Item: 245kV CT

Customer: APTransco, Andhra Pradesh

List of Standard Drawings/Documents:

REV.NO.	DESCRIPTION	APPV'D	REV. DATE
GEN. TOL : NA	MATERIAL : NA		
WEIGHT : NA			
NAME	SIGN	DATE	SPEC : NA
DRAWN	M.D.	07.03.2023	FINISH : NA
CHK'D	M.C.	07.03.2023	
APPV'D	R.P.	07.03.2023	
PFIFNER Instrument Transformers Pvt.Ltd. NASHIK, INDIA			TITLE : GENERAL ARRANGEMENT 245KV CT
SHEET 1 OF 1			REV. NO. : 00

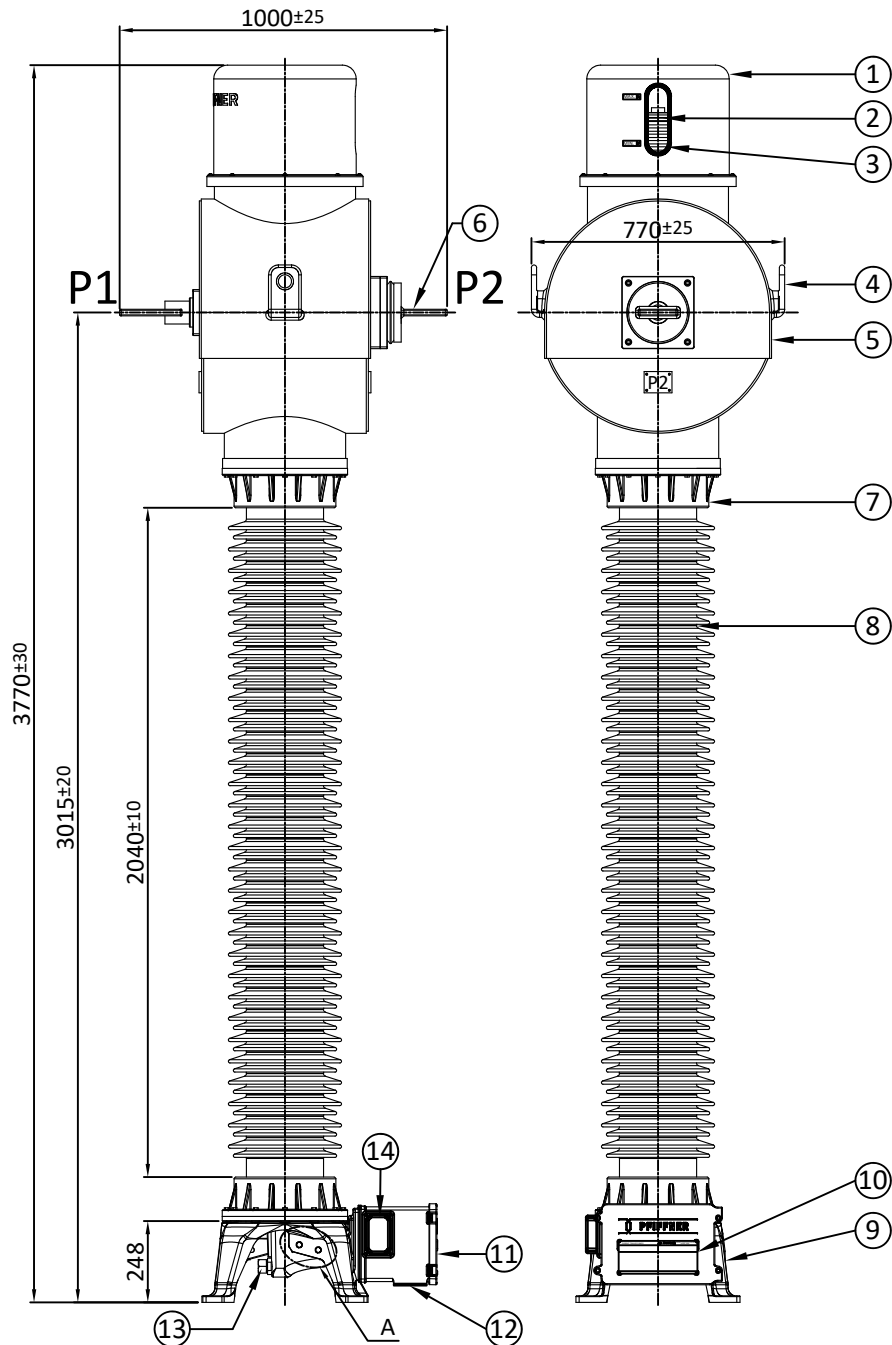
Variation of Tan Delta Value from 10KV $\mu\text{m}/\sqrt{3}$ shall be not exceed 15%.

Drawing approval subject to valid vendor registration

1. Minimum 300mm plinth shall be maintained for CT/PT/CVT/ Isolators/IVT in the substation during foundation works to ensure safe live to ground clearance as per IE rules.
2. Since the supply of terminal connectors is not in the scope of manufacturers as mentioned in the drawings. The EPC contractors shall be instructed to supply the same in line with CT/PT/CVT/Isolator /IVTs requirement and capability.

NOTE:-1. Drawings approval subject to valid type test reports,

to be checked during acceptance tests.

2. For EPC contractors only.

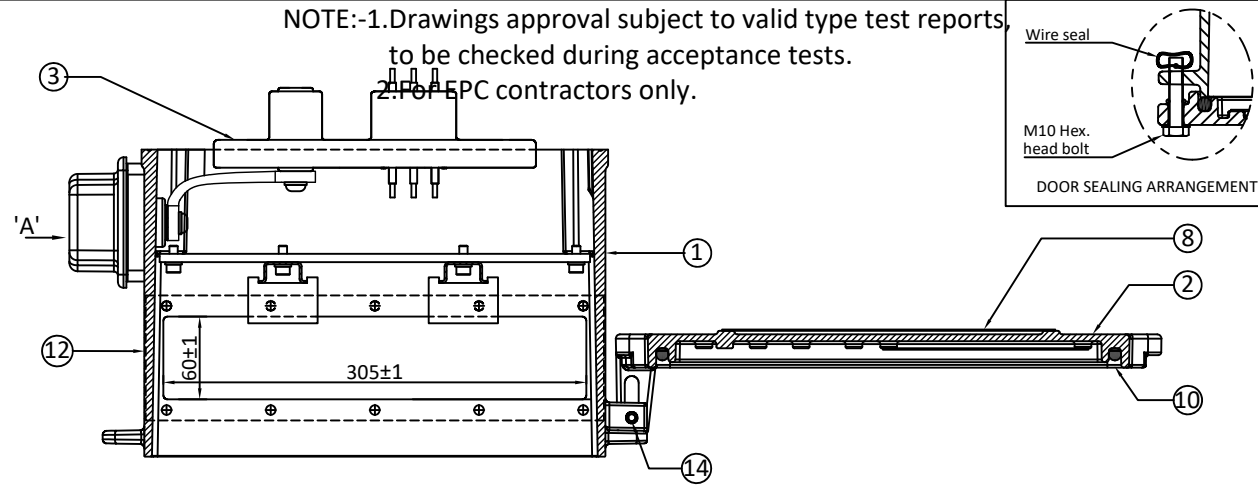
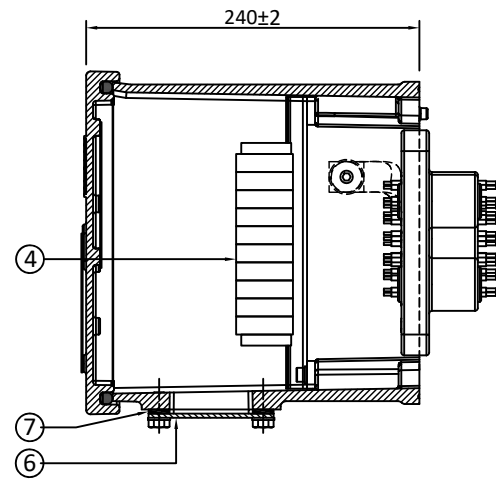
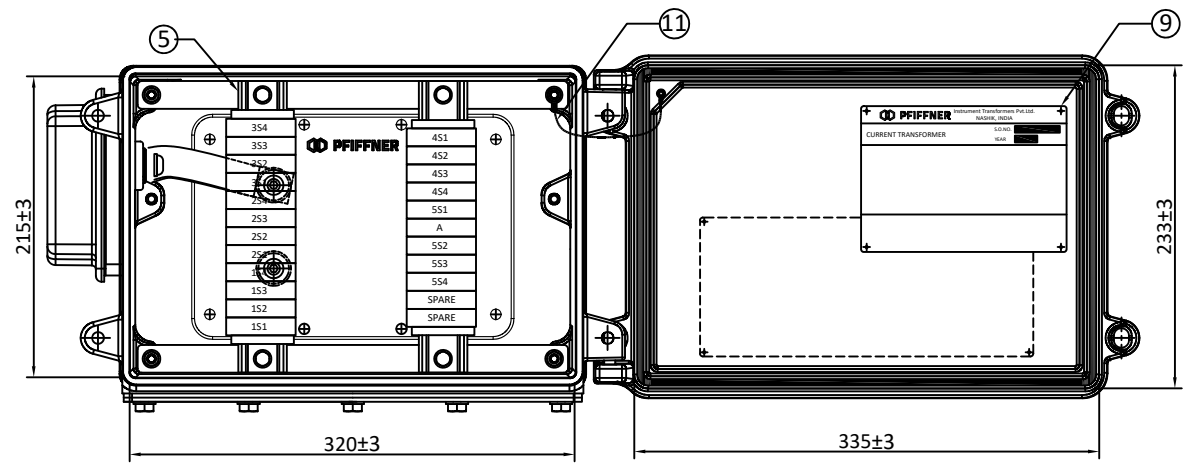
NOTE:-1. Drawings approval subject to valid type test reports to be checked during acceptance tests.
2. For EPC contractors only.

Variation of Tan Delta Value from 10KV um/sqrt 3 shall be not exceed 15%.

Drawing approval subject to valid vendor registration

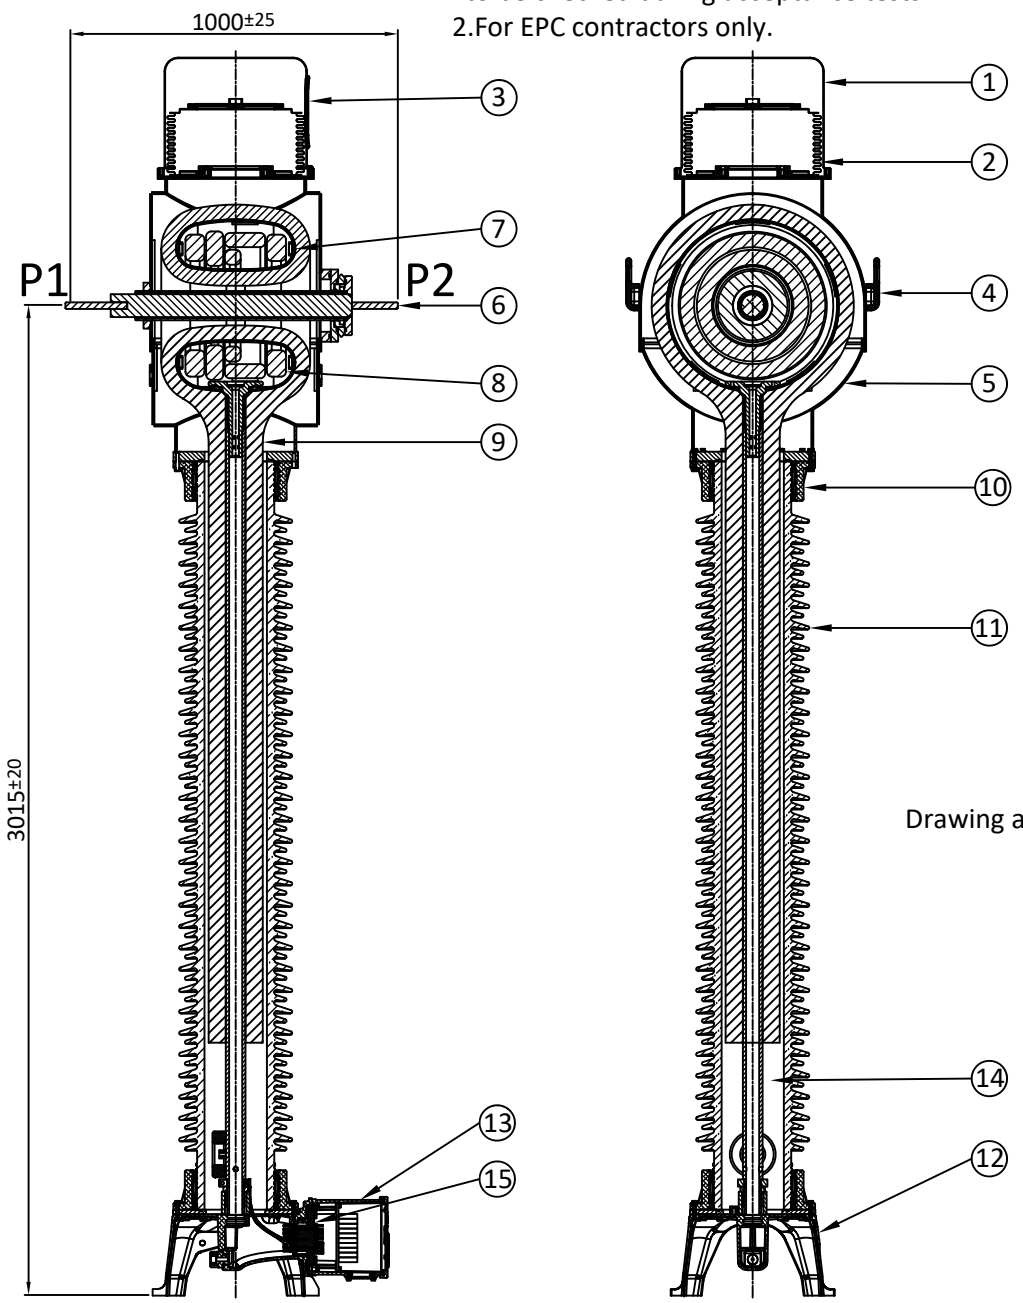
NOTE:-1. Drawings approval subject to valid type test reports, to be checked during acceptance tests.
2. For EPC contractors only.

Drawing approval subject to valid vendor registration

Variation of Tan Delta Value from 10KV um/sqrt 3 shall be not exceed 15%.
